SITE AND ARCHITECTURAL REVIEW COMMITTEE

SARC AGENDA

Subject: Conditional Use Permit with Site and Architectural Review

File No.: PLN-2023-1 ~ 2633 S Bascom Avenue

SHEET TITLE:
FIRE COMMENTS
WATER FLOW

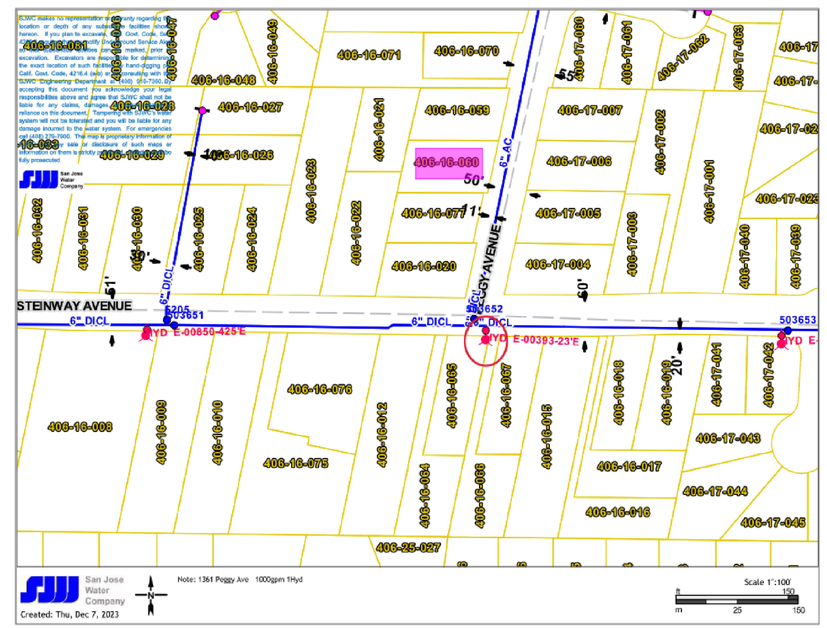
Plan Review Comments:
1. **Required Fire Flow:** The fire flow for this project is 875 GPM at 20 psi residual pressure from a single hydrant. This fire flow assumes the installation of fire sprinklers.
   -Provide a fire flow letter from a local water purveyor confirming the required fire flow of 875 GPM @20 psi residual from a fire hydrant located within 600' of the farthest exterior corner of the structure.
   -Contact San Jose Water for details on how to obtain the fire flow letter.

2. **Fire Sprinklers Required:** An automatic residential fire sprinkler system shall be installed in all new one- and two-family dwellings. *Sprinklers noted on sheet G001.*

3. **Construction Site Fire Safety:** All construction sites must comply with applicable provisions of the CFC Chapter 33 and our Standard Detail and Specification SI-7. Provide appropriate notations on subsequent plan submittals, as appropriate to the project. CFC Chp. 33.

Plans Status:
Plans are **NOT APPROVED.** Revise and resubmit drawings and provide a response letter addressing comments on this plan review. All comments having **BOLD** font require correction prior to approval.
